ADDENDUM #4

Citrus Grove Road Phase 5
Project No. 2023-08, Bid No. 23-562

CITRUS GROVE ROAD
DESIGN PHASE V
FROM WEST SR 91 TO BLACKSTILL LAKE
ROAD

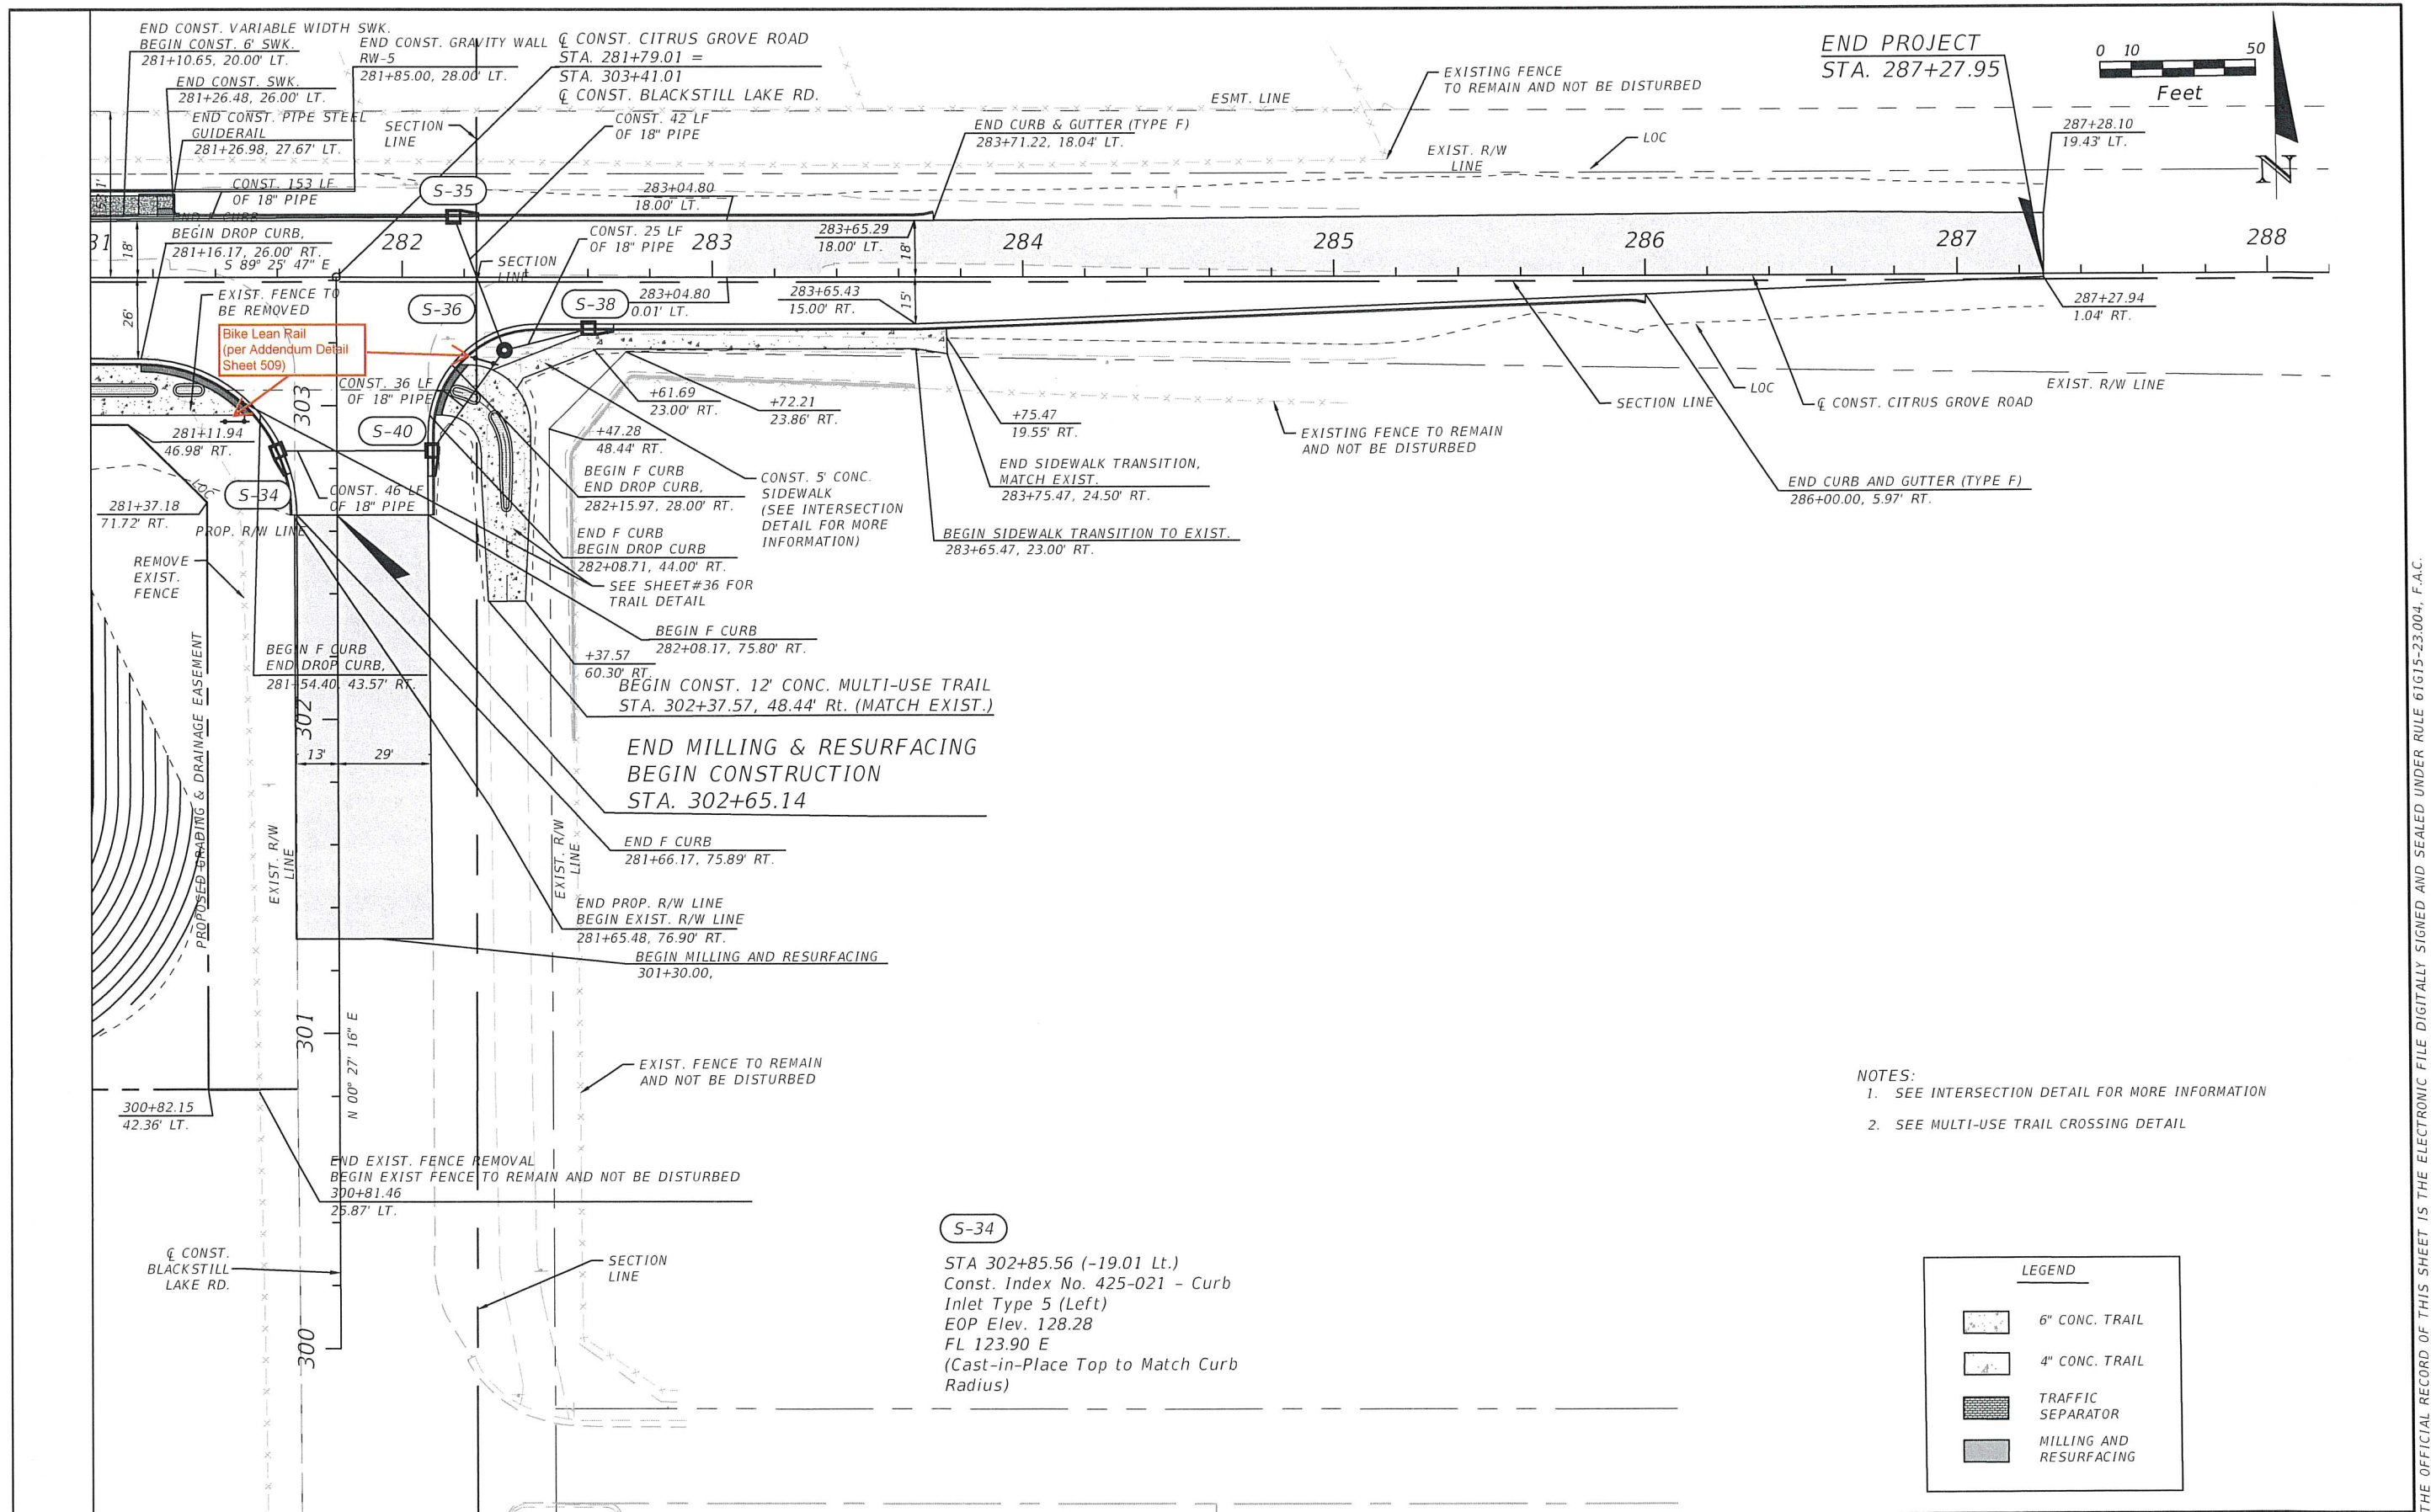
Q5: At Pond WRA-3, there is an existing privacy wall that is not shown on the plans. Is the contractor to install the shown access driveway just up to the privacy wall?

A5: As shown on sheet 21 of the revised construction plans this driveway has been removed from this project.

REVISIONS		DATE			LAKE COUNTY DEPARTMENT OF PUBLIC WORKS ENGINEERING DIVISION		ROADWAY PLAN (7)	SHEET NO. 22
NO.	DESCRIPTION				ROAD	RSQ NO.		
1					CITRUS GROVE ROAD	19-0910	JOHN R. BURKETT, P.E. LICENSE NO. 40064	
							DATE:

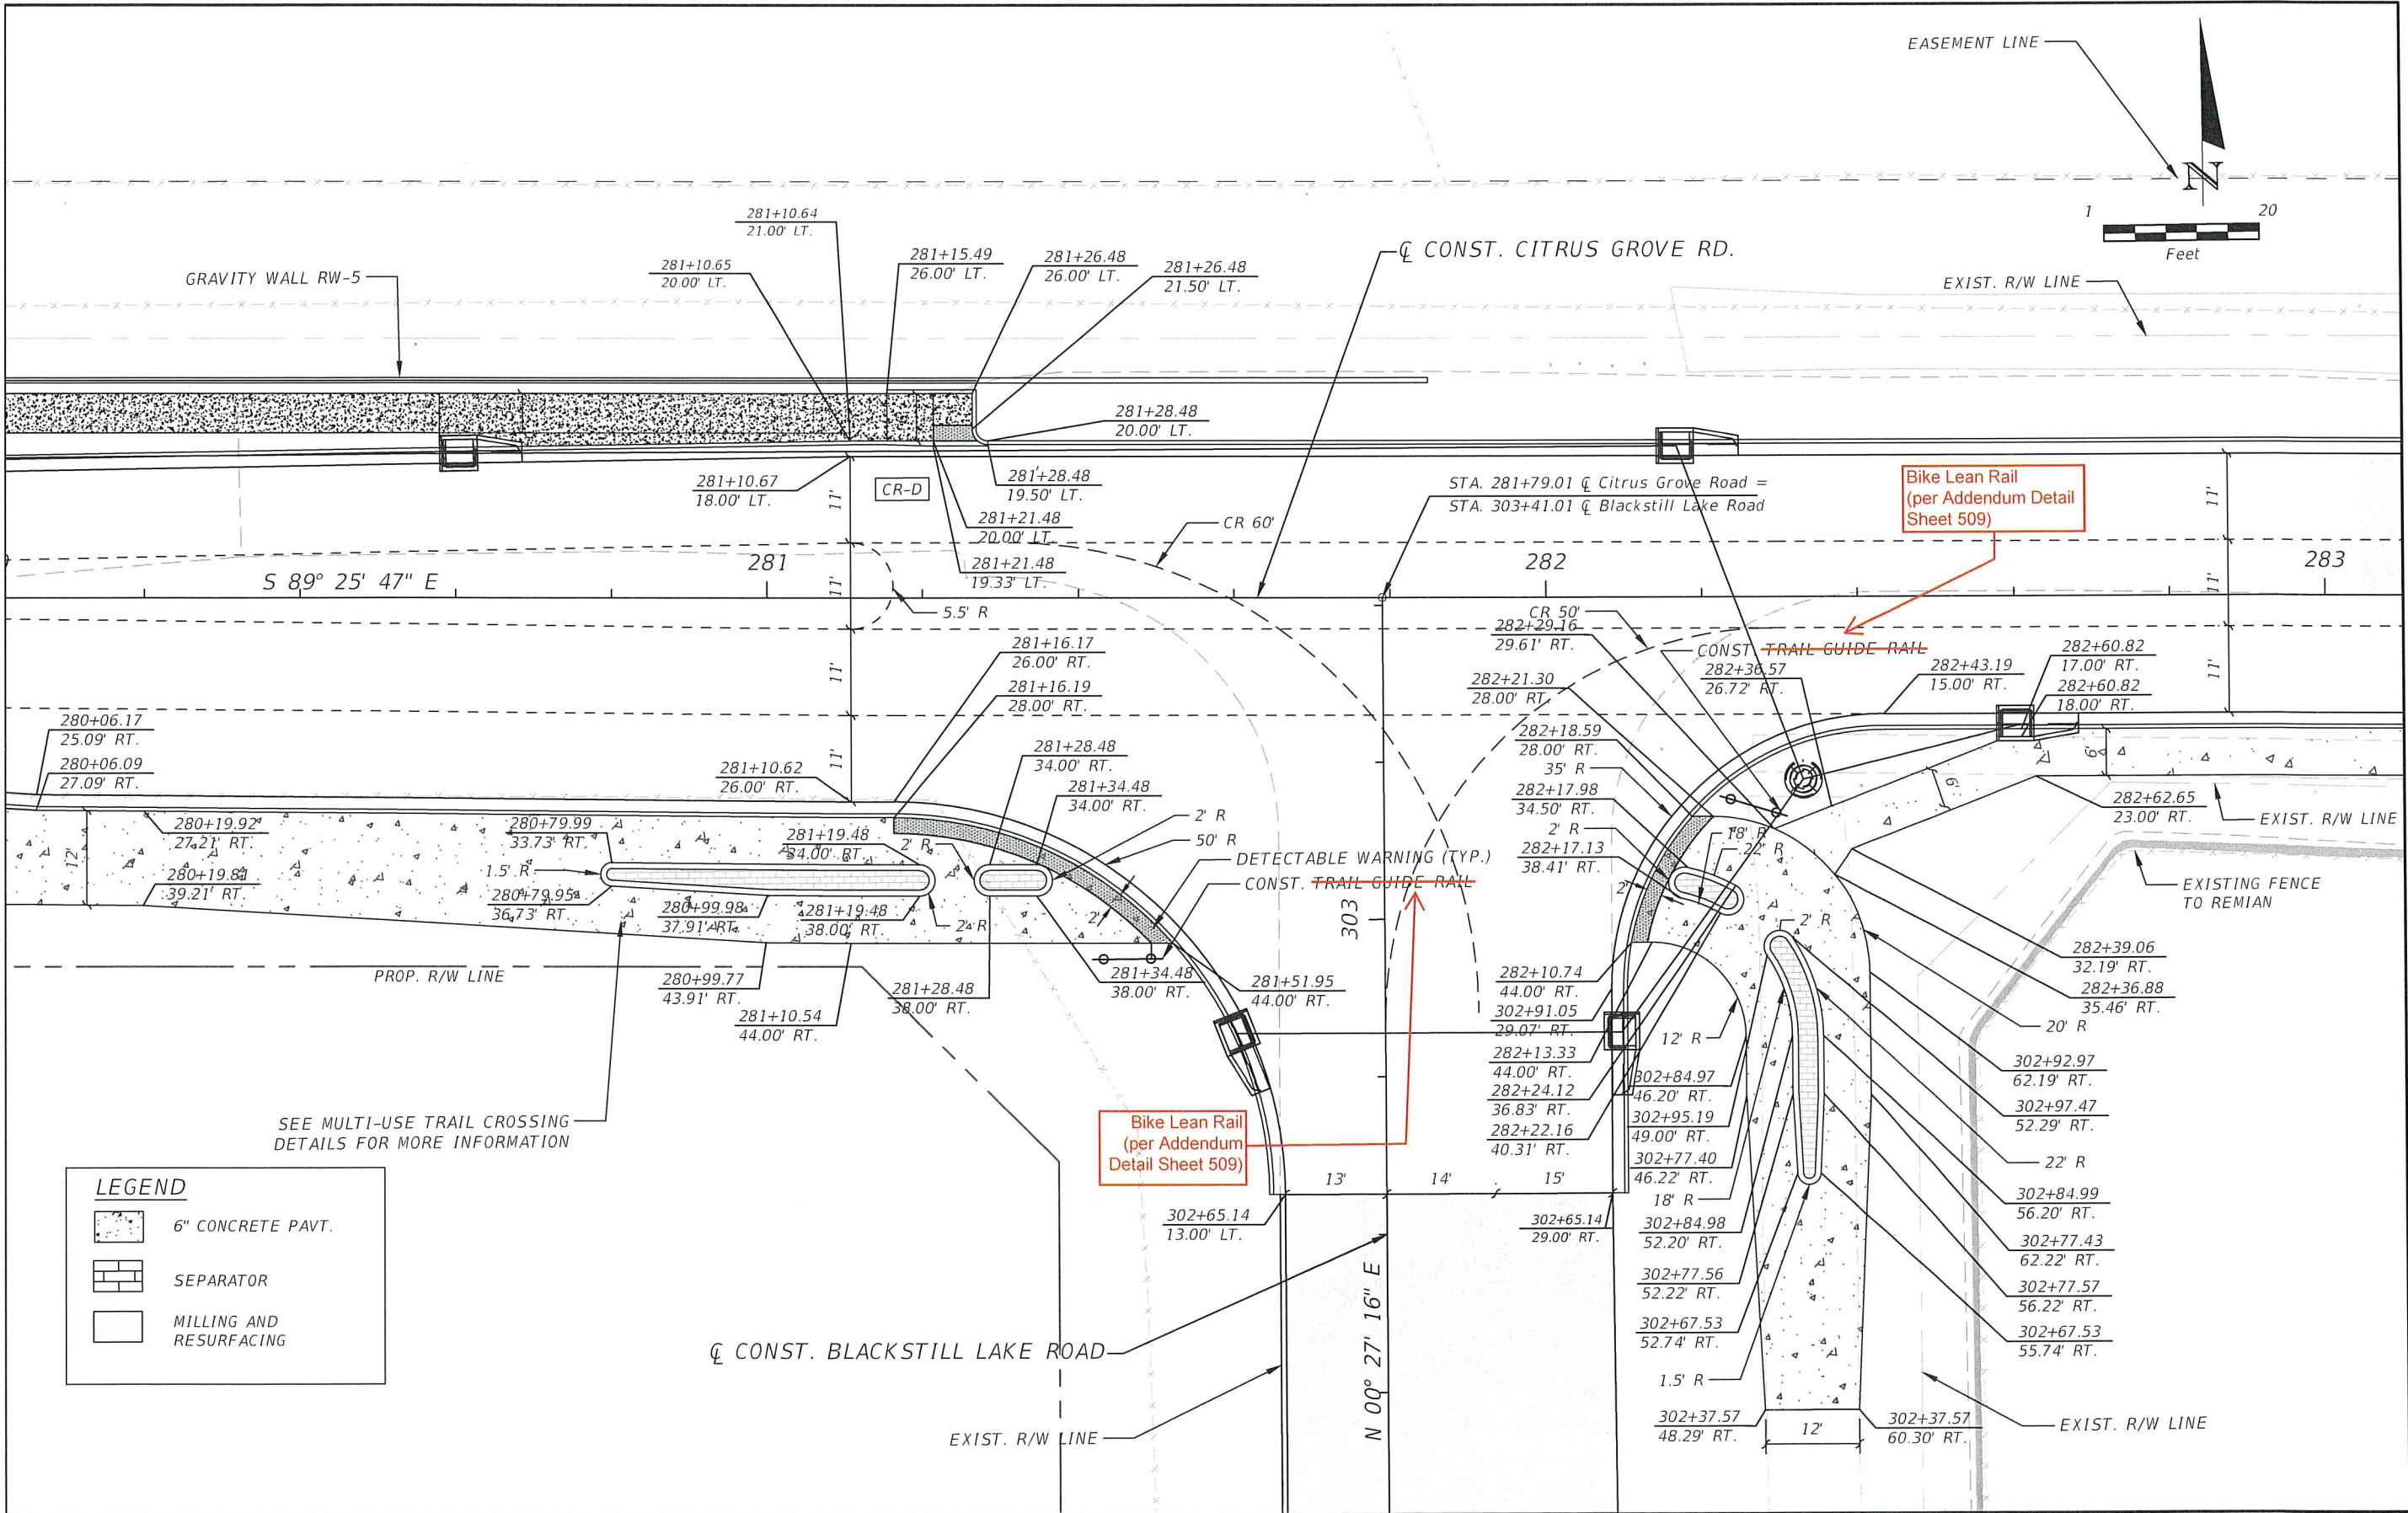
Q9: Can the location of Item 0515-2221, Pedestrian/Bicycle Railing, Steel only, 54' Type 1 be identified please?

A9: Yes, please see revised sheets 18, and 22 identifying the locations of the proposed "Bike Lean" rails. It should also be noted there is an error in the Bid Tabulation; the height of the rail should be 42" not 54' and the bid item number should be 515-1-1 Pipe Handrail- Guiderail, steel. Contractor shall use detail sheet 509 contained within this addendum to construct the "Bike Lean" rail. Contractor shall include in their bid a cost to provide a "Ribbon curb" to fasten the rail to.

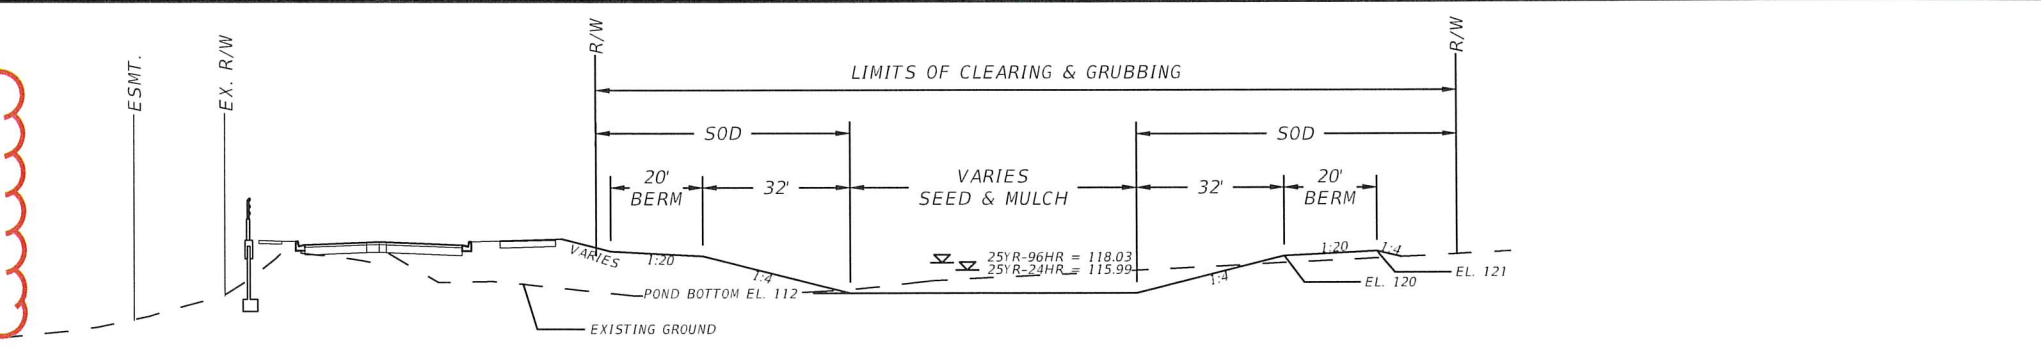
(S-28)
STA 278+95.51 (18.97 Rt.)
Const. Index No. 425-021 - Curb
Inlet Type 6
EOP Elev. 120.87
FL 115.20 N
~~FL 112.20 S~~ 115.20 S

(S-30)
STA 278+95.51 (92.78 Rt.)
Const. Index No. 430-011 -
U-Type Concrete Endwall With
Baffles (1:4 Slope)
~~FL 112.00 N~~ 115.00 N

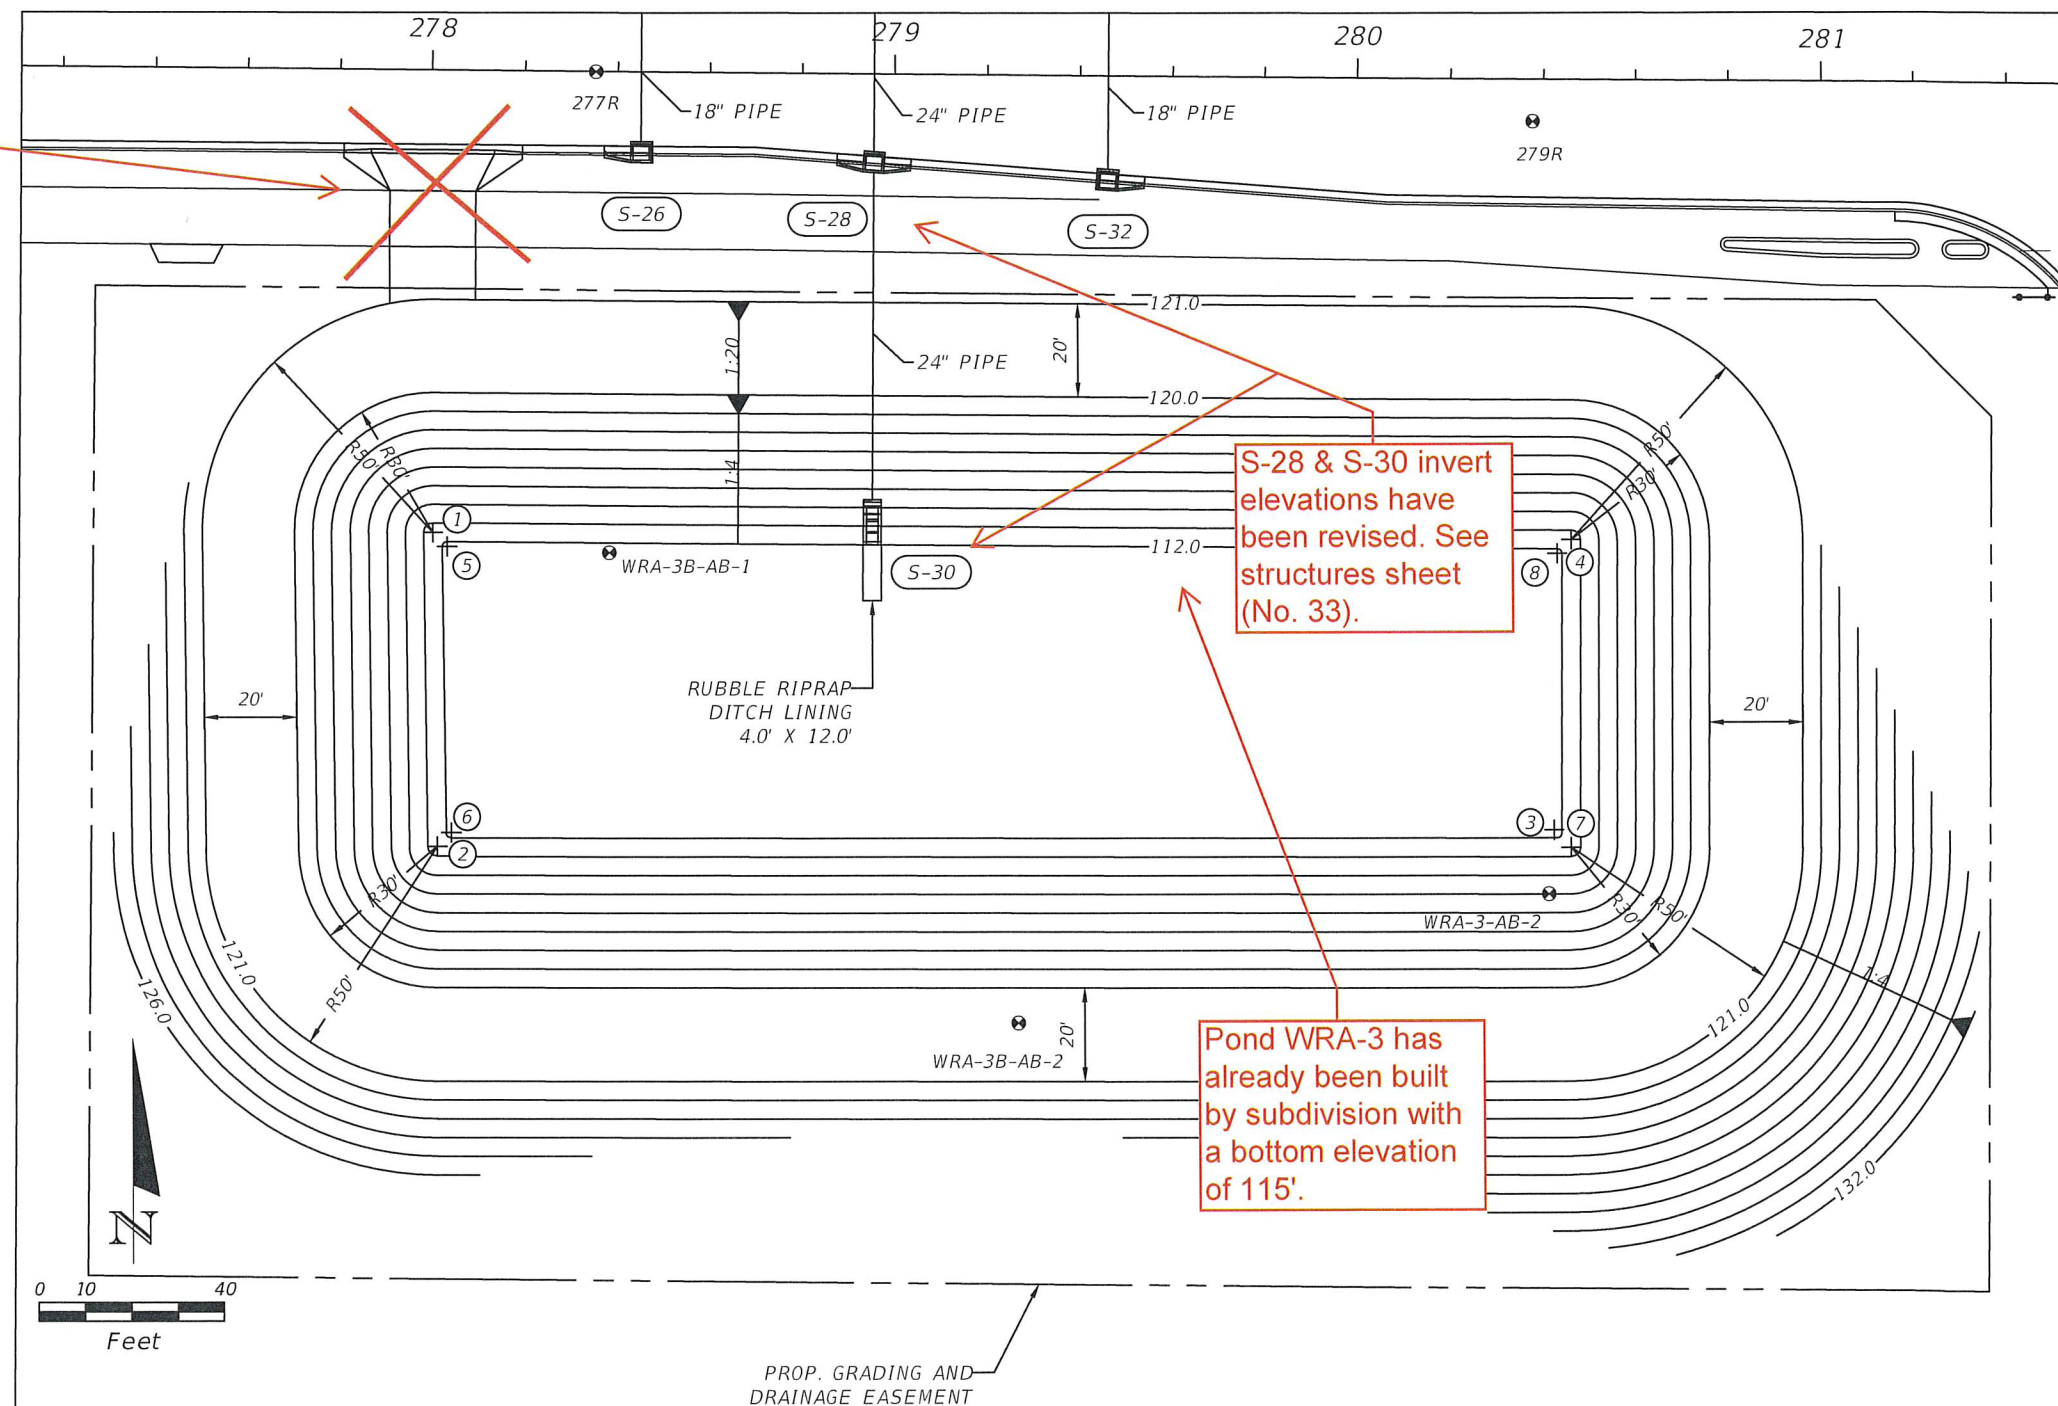
Pond WRA-3 has already been built. It will not need to be built with this roadway plan.

Turnout NOT to be built

A3: The Pond WRA-3 has already been built by Willow Ridge subdivision and has already been re-shaped; however, outfall pipe of this roadway plan needs to be built. Please see attached revised plan sheets 1, 21, 33, 35, and 63 contained within Addendum #4.
